**Figure 7B-1. Signs in School Areas and at School Crossings** (Sheet 1 of 2)

# Summary of Comments on CAMUTCD 2026 7B Fig.pdf

# Summary of Comments on Part 7B Figure CA MUTCD 2026

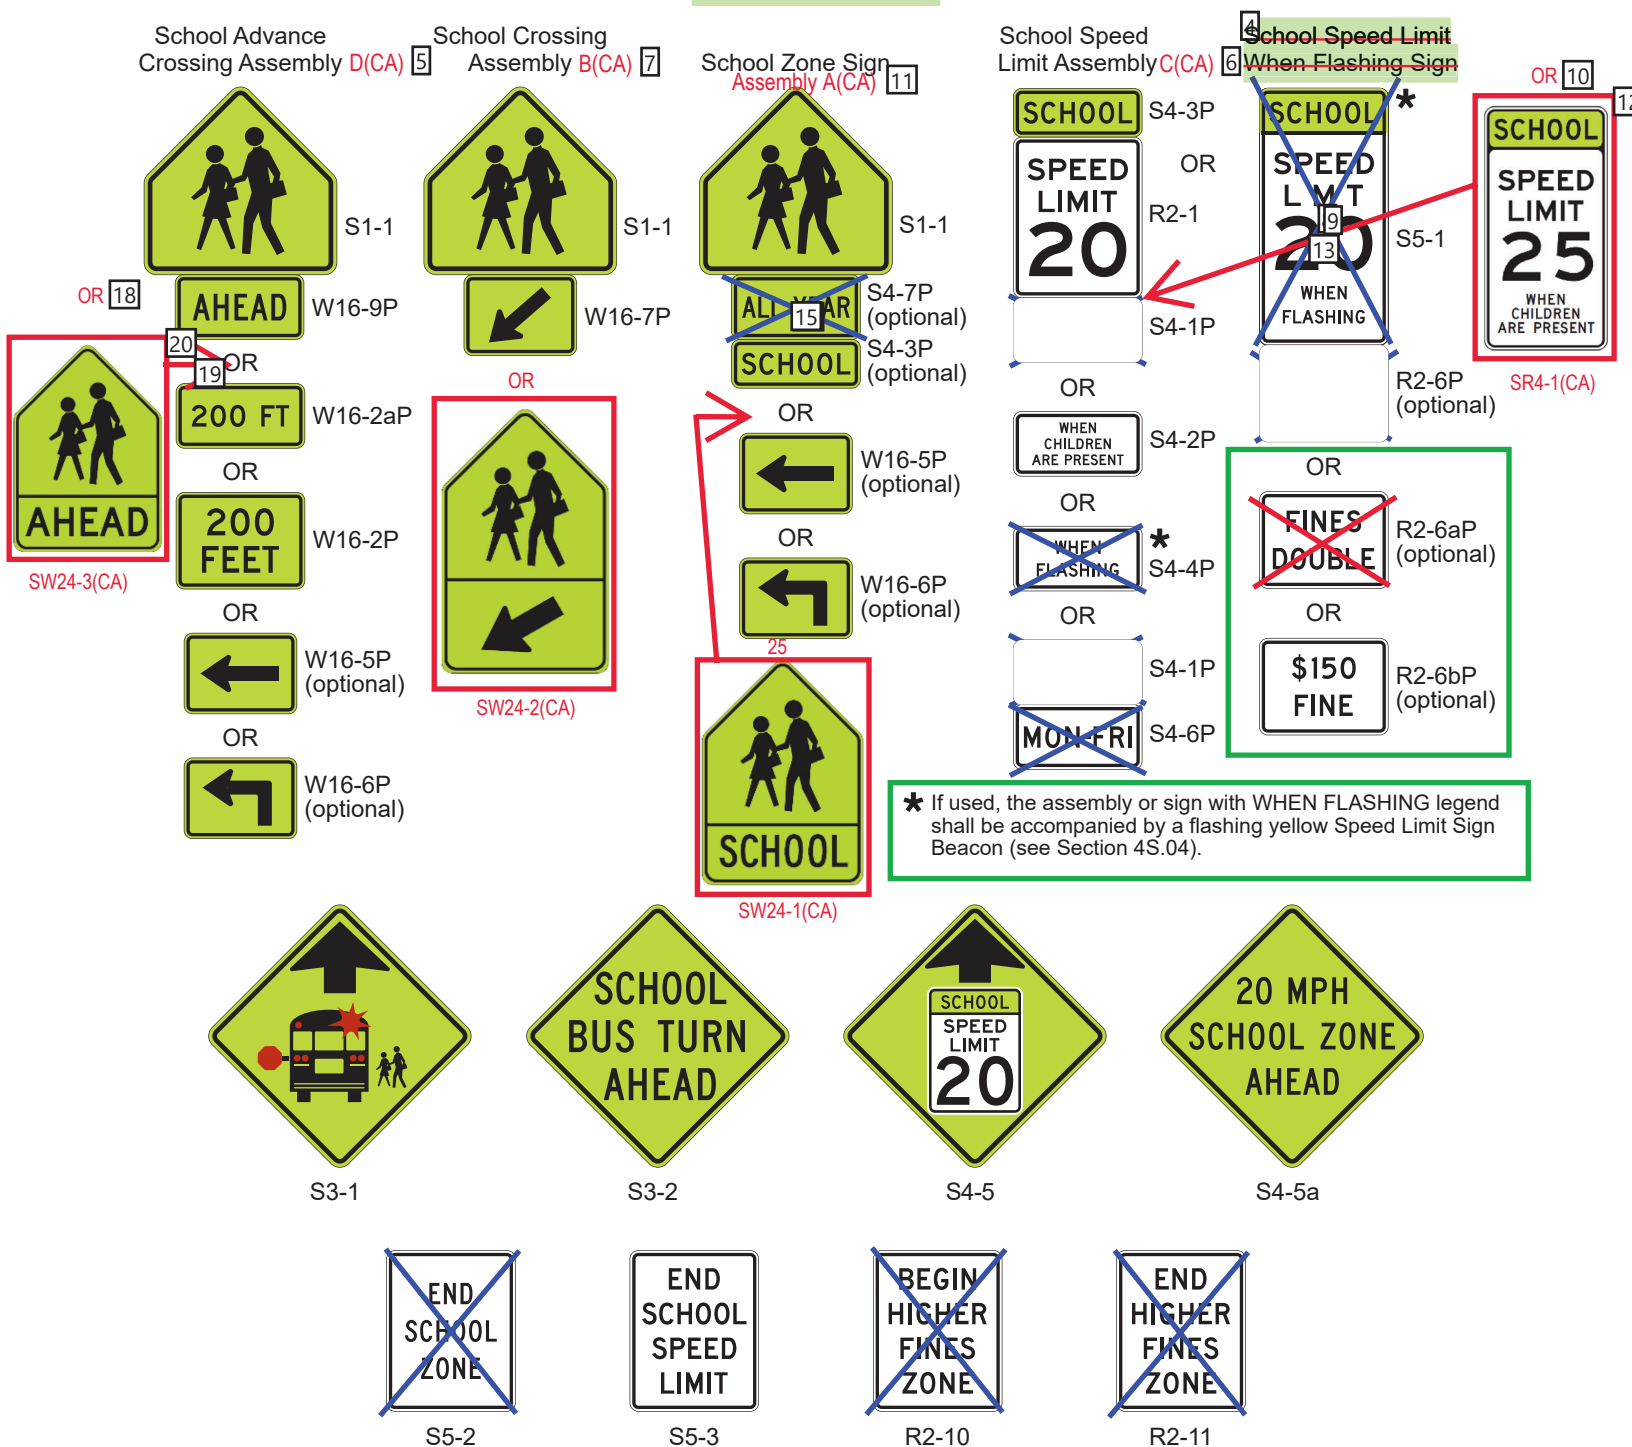
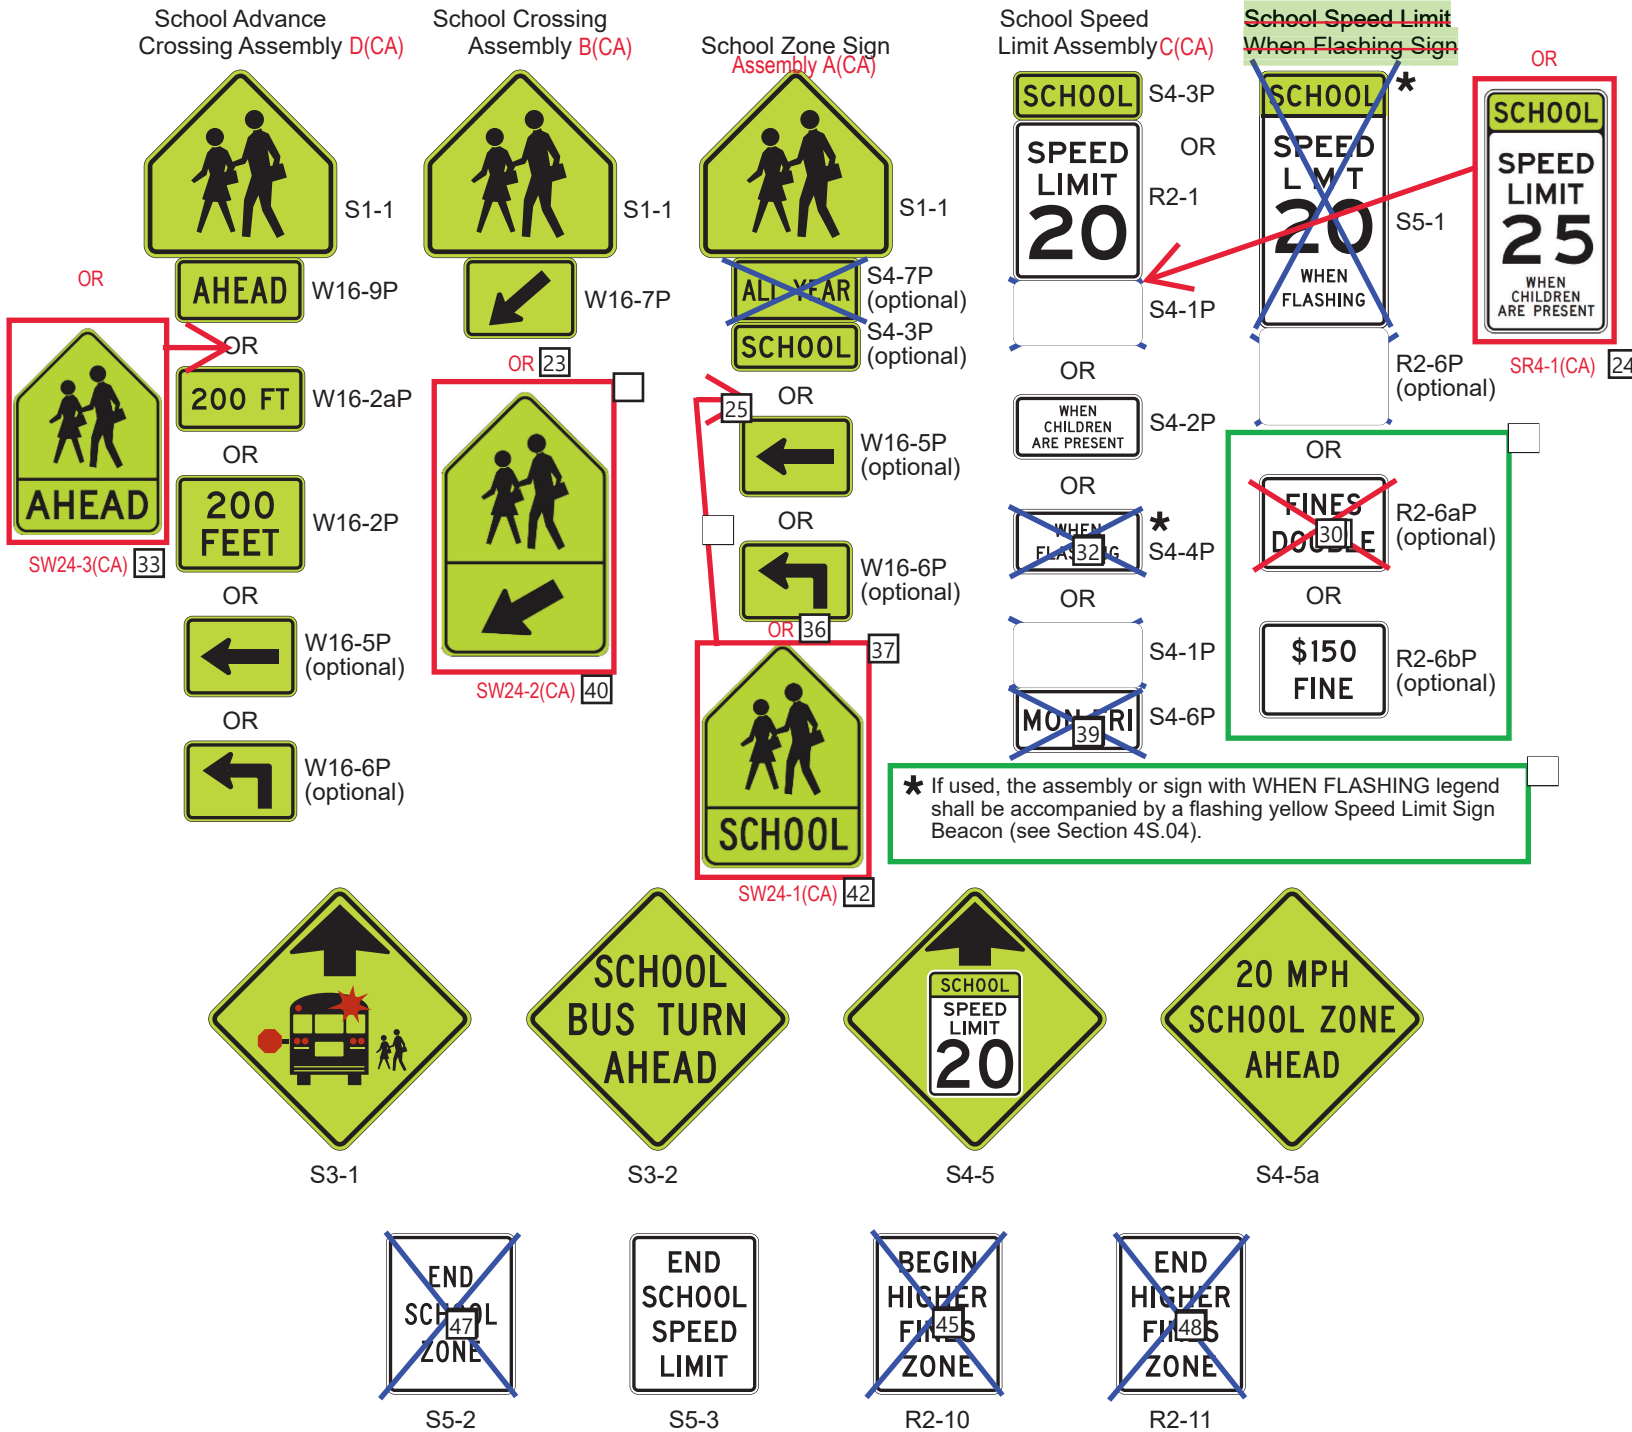
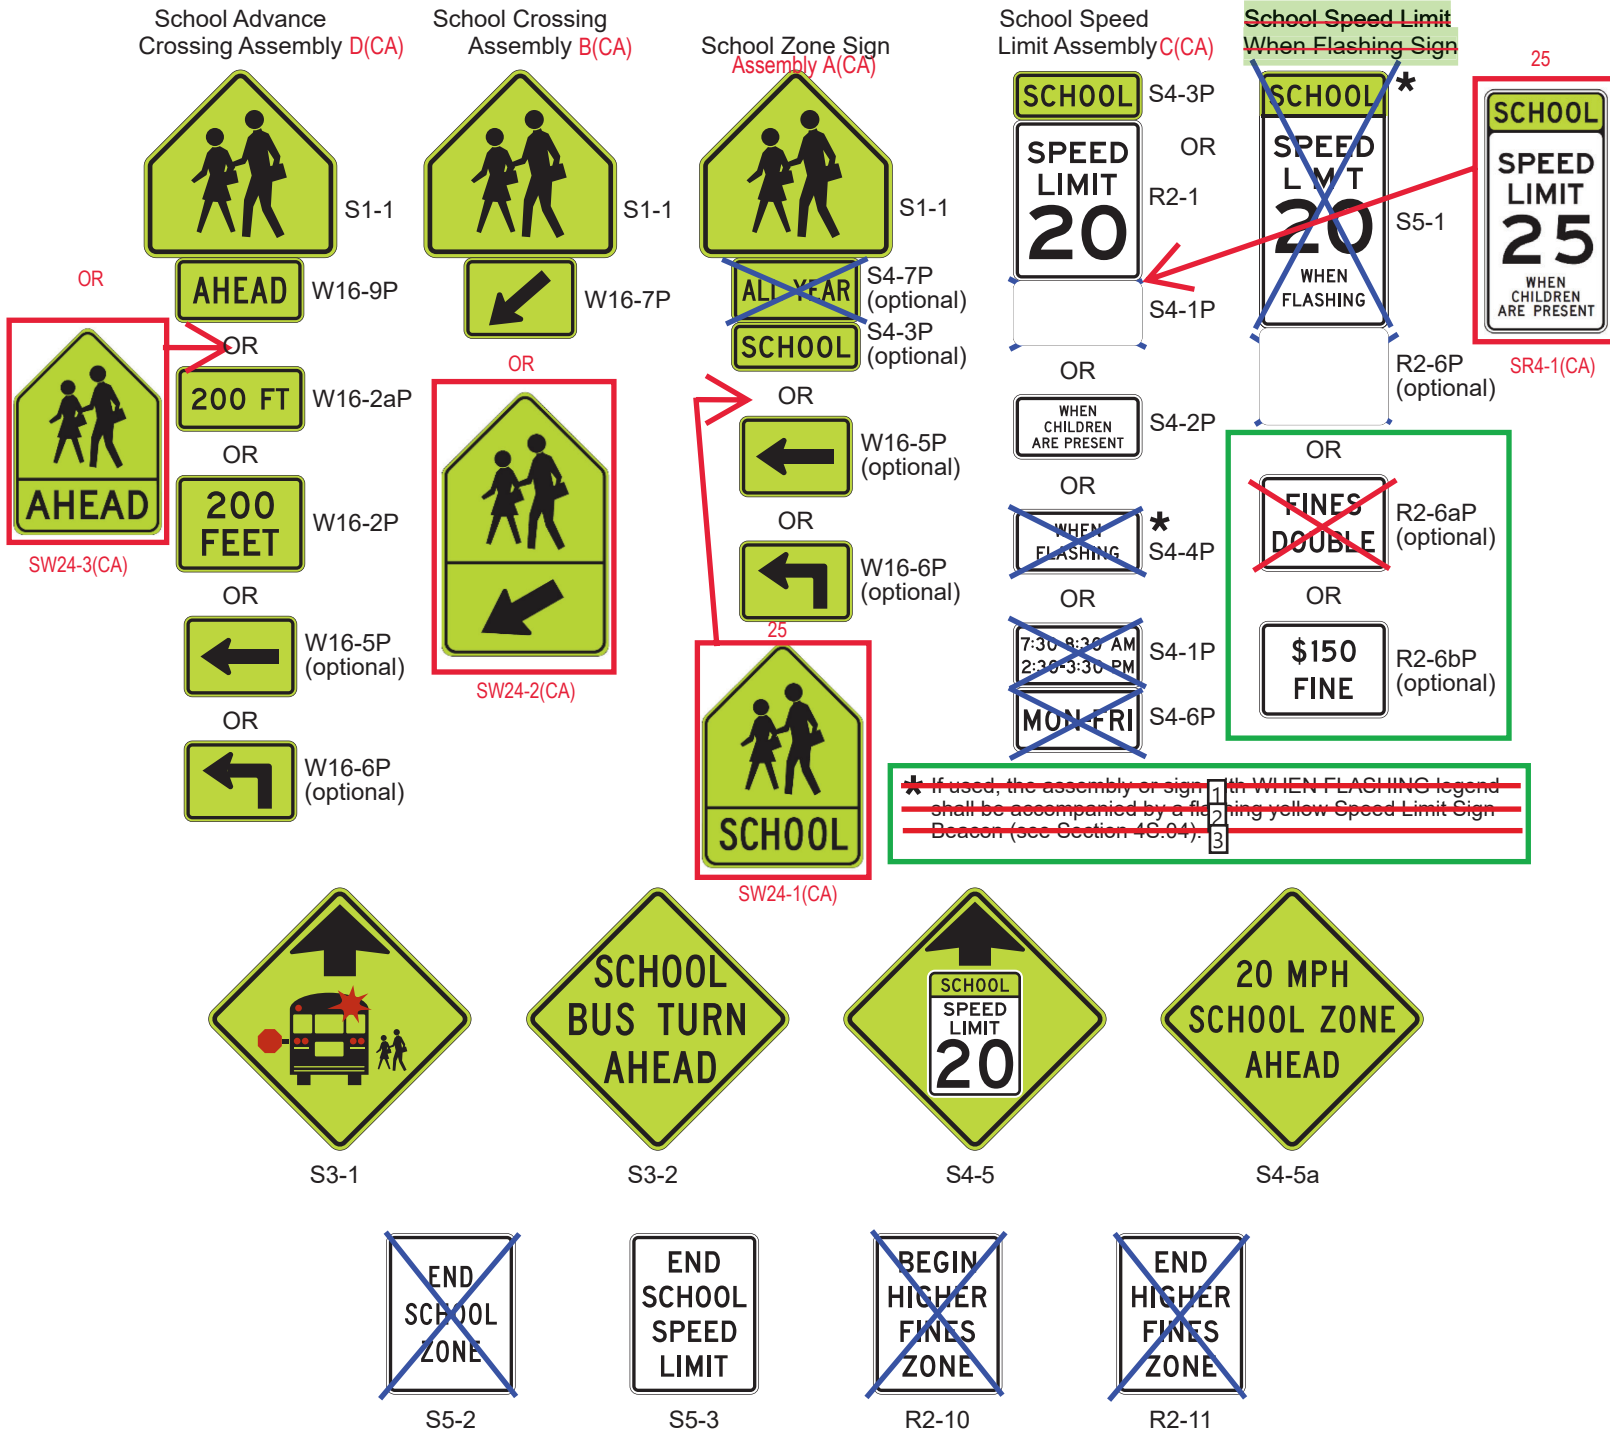
Number: 1	Author: s116730	Subject: Highlight	Date: 7/25/2024 9:46:00 AM
NMUTCD 2023 changed the title of Figure 7B-1 from "School Area Signs" to "Signs in School Areas and at School Crossings" and incorporated signs from NMUTCD 2009 Figures 7B-1 and 7B-6 and added sub-headings A thru D, expanding Figure 7B-1 into 2 sheets.				
NMUTCD 2023 added sign codes for all signs, which were missing in NMUTCD 2009 figures				
	Number: 2	Author: s116730	Subject: Highlight	Date: 7/25/2024 9:46:06 AM
NMUTCD 2023 added sub-heading A				
	Number: 3	Author: s116730	Subject: Cross-Out	Date: 7/8/2024 11:11:18 AM
	Number: 4	Author: s116730	Subject: Highlight	Date: 7/25/2024 9:46:13 AM
NMUTCD 2023 added new text				
	Number: 5	Author: s116730	Subject: Text Box	Date: 7/9/2024 3:32:56 PM
D(CA)				
	Number: 6	Author: s116730	Subject: Text Box	Date: 7/9/2024 4:02:20 PM
C(CA)				
	Number: 7	Author: s116730	Subject: Text Box	Date: 7/9/2024 3:33:04 PM

Number: 20	Author: s116730	Subject: Rectangle	Date: 7/9/2024 3:56:19 PM
Add SW24-3(CA) image in Assembly D(CA) between the W16-9P and W16-2aP				
	Number: 21	Author: s116730	Subject: Line	Date: 7/8/2024 11:12:25 AM
	Number: 22	Author: s116730	Subject: Line	Date: 7/8/2024 11:12:17 AM

Number: 23	Author: s116730	Subject: Text Box	Date: 7/9/2024 3:57:09 PM
OR				
	Number: 24	Author: s116730	Subject: Text Box	Date: 7/9/2024 4:04:01 PM
SR4-1(CA)				
	Number: 25	Author: s116730	Subject: Line	Date: 7/9/2024 4:07:36 PM
	Number: 26	Author: s116730	Subject: Rectangle	Date: 7/9/2024 3:59:42 PM
Add SW24-2(CA) image in Assembly D(CA) below the W16-7P				
	Number: 27	Author: s116730	Subject: Line	Date: 7/9/2024 4:06:50 PM
	Number: 28	Author: s116730	Subject: Rectangle	Date: 7/13/2024 10:03:54 AM
NMUTCD 2023 added new signs				
	Number: 29	Author: s116730	Subject: Line	Date: 7/8/2024 11:16:39 AM
	Number: 30	Author: s116730	Subject: Line	Date: 7/8/2024 11:16:39 AM
	Number: 31	Author: s116730	Subject: Line	Date: 7/8/2024 10:57:28 AM
	Number: 32	Author: s116730	Subject: Line	Date: 7/8/2024 10:57:13 AM
	Number: 33	Author: s116730	Subject: Text Box	Date: 7/9/2024 3:56:26 PM
SW24-3(CA)				
	Number: 34	Author: s116730	Subject: Line	Date: 7/8/2024 10:58:34 AM

Number: 35	Author: s116730	Subject: Line	Date: 7/8/2024 10:58:34 AM
	Number: 36	Author: s116730	Subject: Text Box	Date: 7/9/2024 3:57:52 PM
OR				
	Number: 37	Author: s116730	Subject: Rectangle	Date: 7/9/2024 3:47:20 PM
Add SW24-1(CA) image in Assembly A(CA) between the S4-3P and W16-5P				
	Number: 38	Author: s116730	Subject: Line	Date: 7/8/2024 10:58:51 AM
	Number: 39	Author: s116730	Subject: Line	Date: 7/8/2024 10:58:51 AM
	Number: 40	Author: s116730	Subject: Text Box	Date: 7/9/2024 3:58:56 PM
SW24-2(CA)				
	Number: 41	Author: s116730	Subject: Rectangle	Date: 7/13/2024 10:04:44 AM
NMUTCD 2023 added new note				
	Number: 42	Author: s116730	Subject: Text Box	Date: 7/9/2024 3:57:21 PM
SW24-1(CA)				
	Number: 43	Author: s116730	Subject: Line	Date: 7/8/2024 11:13:52 AM
	Number: 44	Author: s116730	Subject: Line	Date: 7/8/2024 11:13:18 AM
	Number: 45	Author: s116730	Subject: Line	Date: 7/8/2024 11:13:52 AM

~~Figure 7B-1(CA). School Area Signs (Sheet 2 of 2)~~  
**Figure 7B-1(CA). Signs in School Areas and at School Crossings**

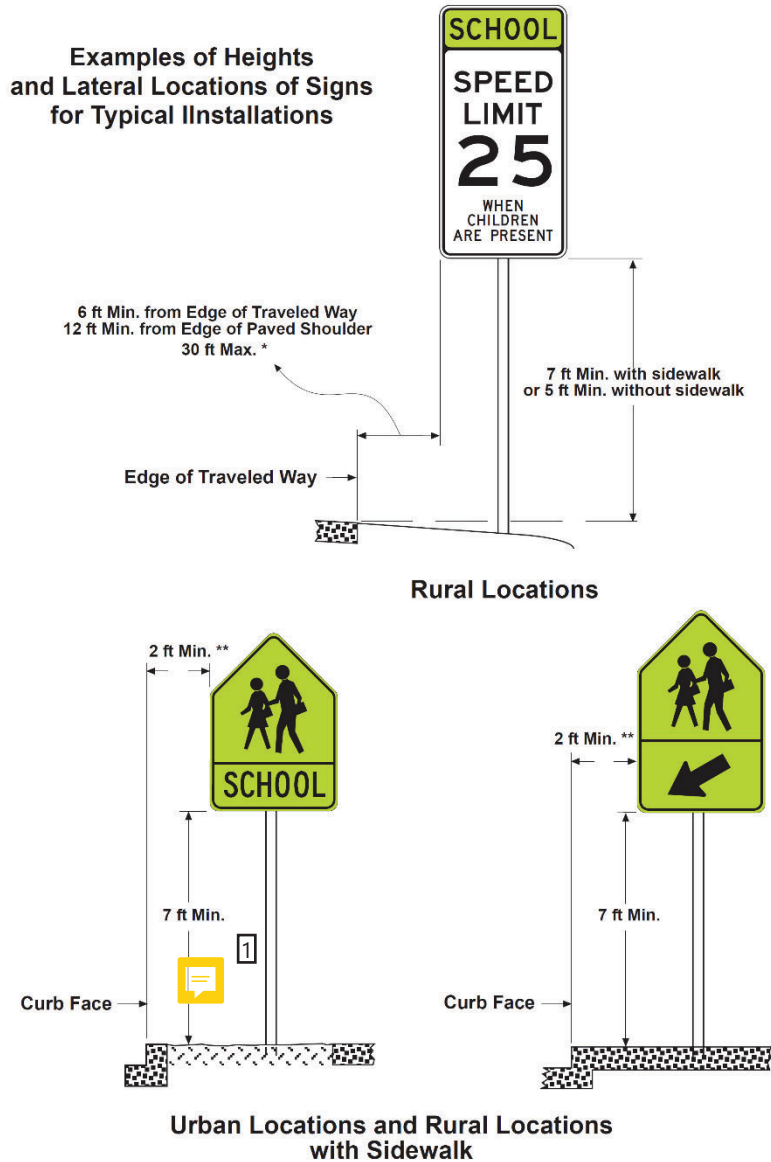
Number: 1	Author: s116730	Subject: Highlight	Date: 7/25/2024 9:46:47 AM
NMUTCD 2023 changed the title of Figure 7B-1 from "School Area Signs" to "Signs in School Areas and at School Crossings" and incorporated signs from NMUTCD 2009 Figures 7B-1 and 7B-6 and added sub-headings A thru D, expanding Figure 7B-1 into 2 sheets.				
NMUTCD 2023 added sign codes for all signs, which were missing in NMUTCD 2009 figures				
	Number: 2	Author: s116730	Subject: Highlight	Date: 7/25/2024 9:46:51 AM
NMUTCD 2023 changed sub-heading A in NMUTCD 2009 Figure 7B-6 to B				
	Number: 3	Author: s116730	Subject: Line	Date: 7/10/2024 8:44:02 AM
	Number: 4	Author: s116730	Subject: Line	Date: 7/10/2024 8:44:02 AM
	Number: 5	Author: s116730	Subject: Rectangle	Date: 7/13/2024 10:07:09 AM
NMUTCD 2023 added new signs				
	Number: 6	Author: s116730	Subject: Highlight	Date: 7/25/2024 9:47:03 AM
NMUTCD 2023 changed sub-heading B in NMUTCD 2009 Figure 7B-6 to C

NMUTCD 2023 changed sign code from R1-9 in NMUTCD 2009 to R1-9b and added this text description.				
	Number: 18	Author: s116730	Subject: Highlight	Date: 7/25/2024 9:47:33 AM
	Number: 19	Author: s116730	Subject: Highlight	Date: 7/25/2024 9:47:28 AM
NMUTCD 2023 added this text in the Note #1. Note #1 previously was in NMUTCD 2009 Figure 7B-6.				
	Number: 20	Author: s116730	Subject: Highlight	Date: 7/25/2024 9:47:38 AM
NMUTCD 2023 added new note

Author: Johnny Bhullar      Subject: Sticky Note      Date: 3/28/2025 10:05:44 AM  
Revise single line text "7 ft. Min." to two line text, with 1st line as "7 ft. Min. (Urban)" and second line as "5 ft. Min. (Rural)"

Author: Johnny Bhullar      Subject: Sticky Note      Date: 3/28/2025 9:58:53 AM  
Add Note:  
"A 4-foot minimum unobstructed pedestrian access route should be maintained."

Number: 1      Author: s116730      Subject: Sticky Note      Date: 7/16/2024 7:58:04 AM  
Figure name changed to match NMUTCD 2023 Figure 7B-1 name and text for "(Sheet 2 of 2)" is deleted.

Number: 3      Author: s116730      Subject: Cross-Out      Date: 7/25/2024 9:48:03 AM  
NMUTCD 2023 changed the title of Figure 7B-1 from "School Area Signs" to "Signs in School Areas and at School Crossings"
